## Memorandum

**DATE:** August 7, 2009  
**TO:** Katie Walker, Southwest Transitway Project Manager  
**FROM:** Dax Kuhfuss  
**RE:** Freight Rail Considerations  
**CC:** O. Gonzalez, M. Elabbady, S. Reed

The purpose of this memo is to document the design decisions made regarding freight rail track within the proposed LRT corridor. Two specific questions regarding the existing freight rail and their design decisions are discussed below.

KENILWORTH CORRIDOR TYPICAL SECTIONS - SHEET 1 OF 1

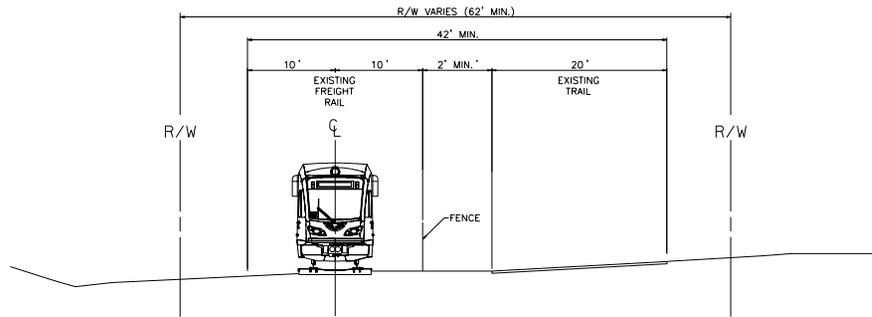
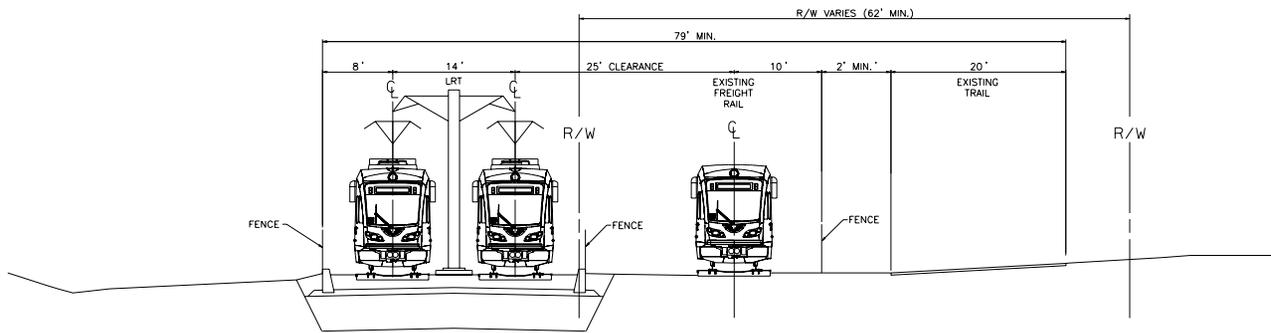
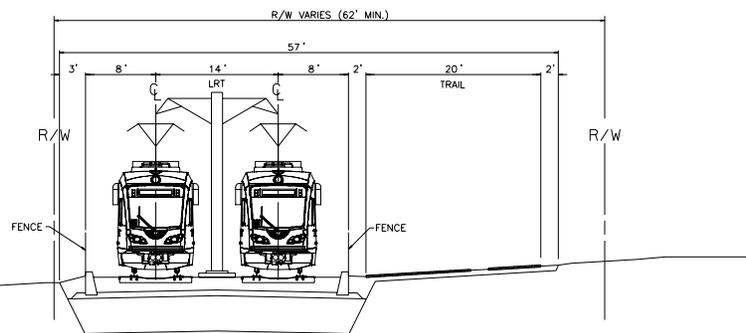
Is it possible to accommodate the existing freight rail, proposed LRT, and pedestrian trail within the project right-of-way in the Kenilworth area of Segment A?

The existing corridor through the Kenilworth area contains an active freight rail track and a 20 feet wide pedestrian trail. The project right-of-way through this area varies slightly, but is a minimum of 62 feet wide. This information is depicted by the Existing Condition typical section of the Kenilworth Corridor Typical Sections sheet.

Maintaining these existing services in addition to the proposed LRT at-grade was first investigated. The proposed LRT track would require approximately 30 feet of width. TC&W operates the existing freight rail has stated that they would require 25' of separation between the freight track and any proposed LRT track. Due to safety concerns it was determined undesirable to place the pedestrian trail between the freight rail and LRT tracks. Therefore, no matter the arrangement, the 25' clearance between the freight rail track and LRT track would be required. As illustrated by the Accommodate All typical section at least an additional 17' of right-of-way would be required. Acquisition of additional right-of-way along the corridor for this purpose was believed to be cost prohibitive.

Removing freight rail operation from this corridor to allow LRT and trail operation was also considered. The Proposed Condition typical section illustrates this on the Kenilworth Corridor Typical Sections sheet. Removal of the freight rail allows the needed width to accommodate the proposed LRT and pedestrian trail within the existing right-of-way. Discontinuing freight rail through the Kenilworth area appears to provide the most viable method for construction of LRT through this area.
